AERONAUTICAL ACCESSORIES, INC.

TECHNICAL BULLETIN

TB No. AA-01159

PC Safety Valve™ Kit:

FIGURE 1
AIR INDUCTION SCREEN

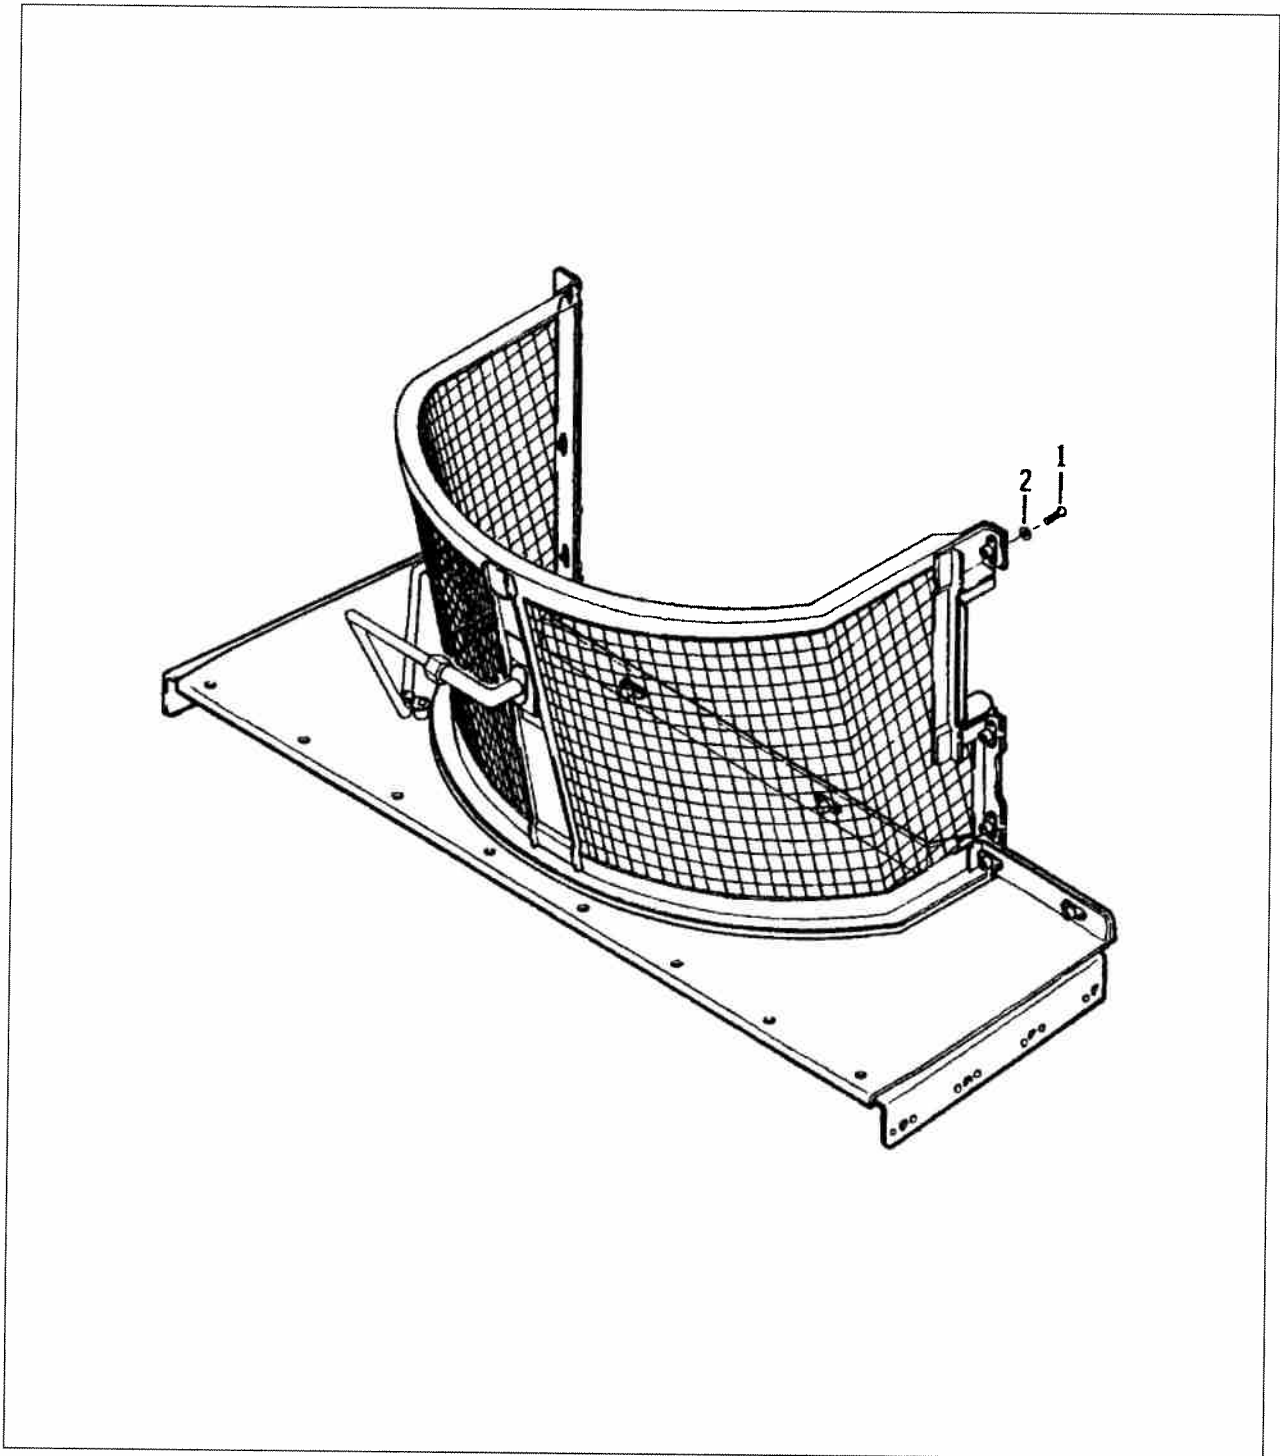
4. Assure proper alignment of Pc Sense Line to Pc Safety Valve™ by hand tightening Pc line B-nuts up to final one half turn. Secure the Pc line by torquing B-nuts to 80 to 120 in-lbs.
5. Remove temporary marking from Pc Sense Line Assembly (250-957-105).
6. If an air induction screen is present, remove attaching bolt (AN3-3A) from the air induction screen and retain washer. Refer to Figure 1, items 1 and 2.

FIGURE 2
CLAMP INSTALLATION

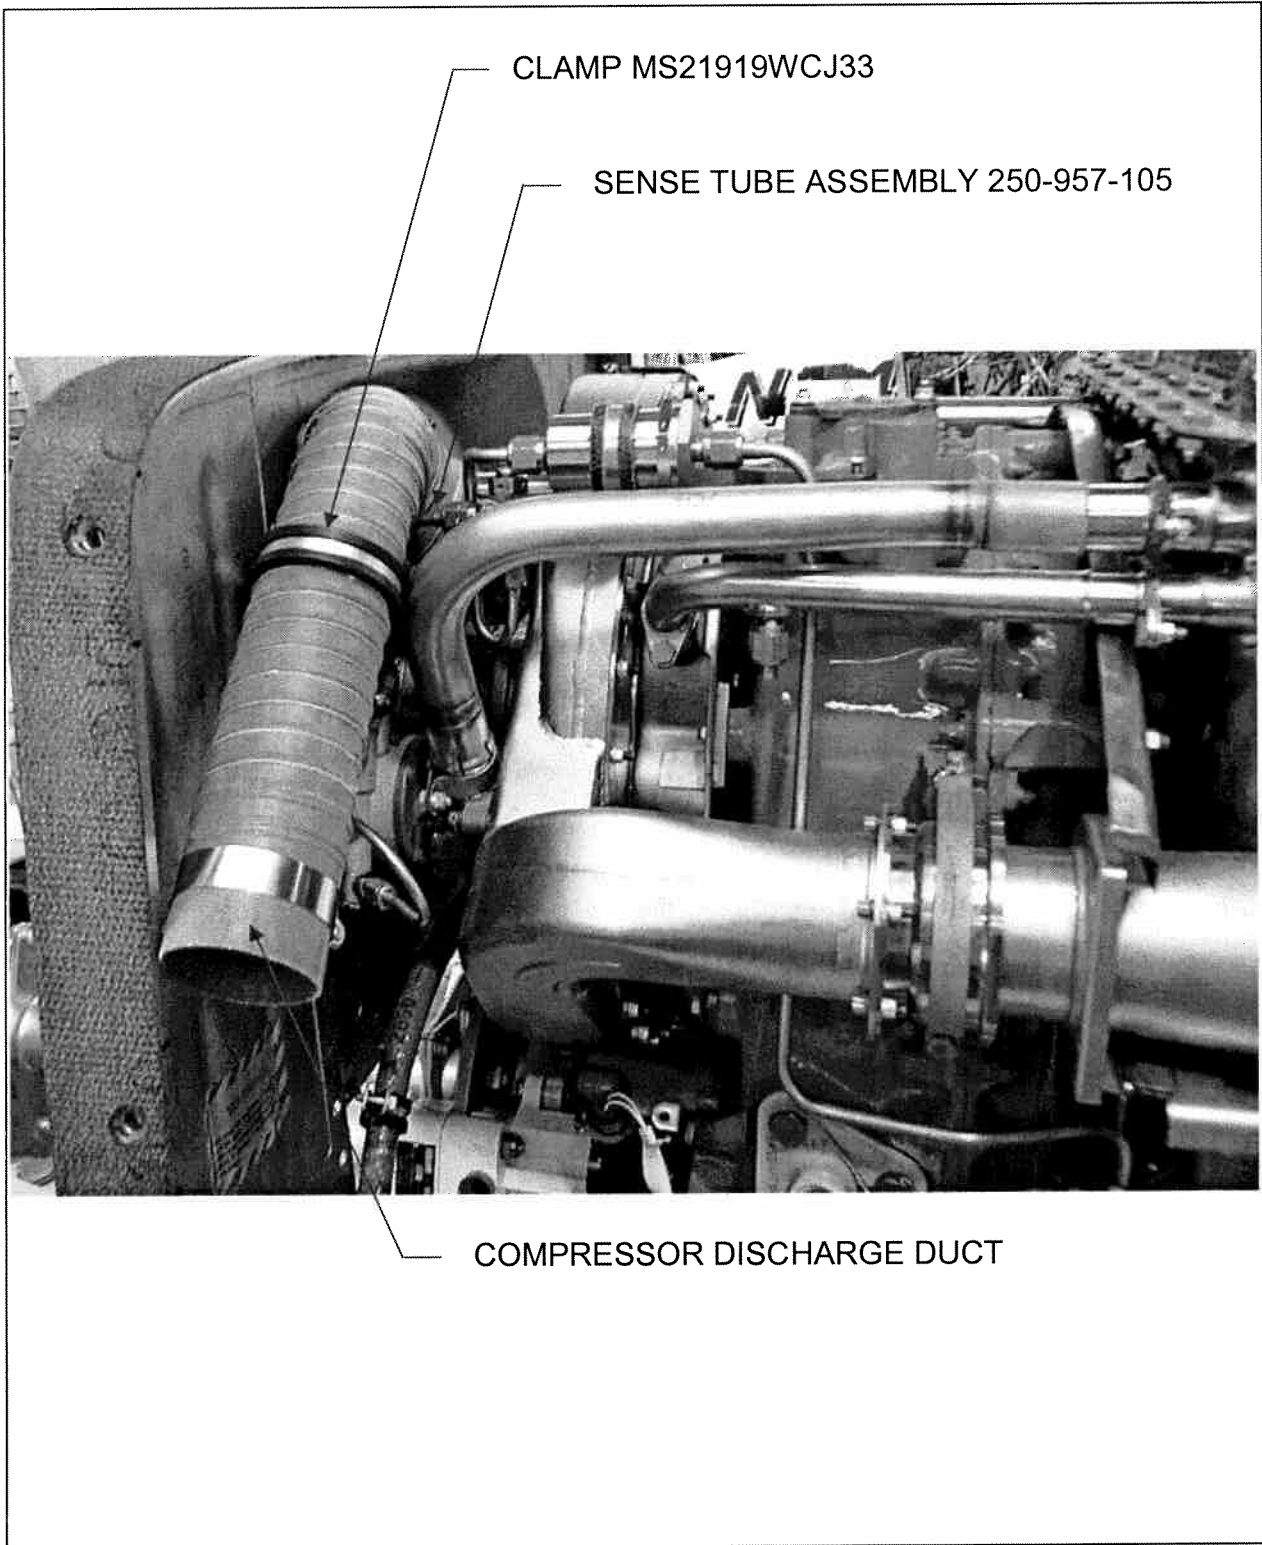
7. Position clamp (MS21919WCJ33) around the compressor discharge duct and attach to air induction screen nut plate using bolt (AN3-5A) provided and the washer retained in step 1. Refer to Figure 2. Do not tighten bolt (AN3-5A) at this time.
8. If an air induction screen is not present, use same hole with nut (MS21042-3) provided to secure clamp.
9. Adjust the compressor discharge duct and clamp (MS21919WCJ33) as necessary so that the compressor discharge duct arches over the Pc Sense Line Assembly (250-957-105) without touching it. Refer to Figure 2.
10. Torque bolt (AN3-5A) 20-25 in-lbs.
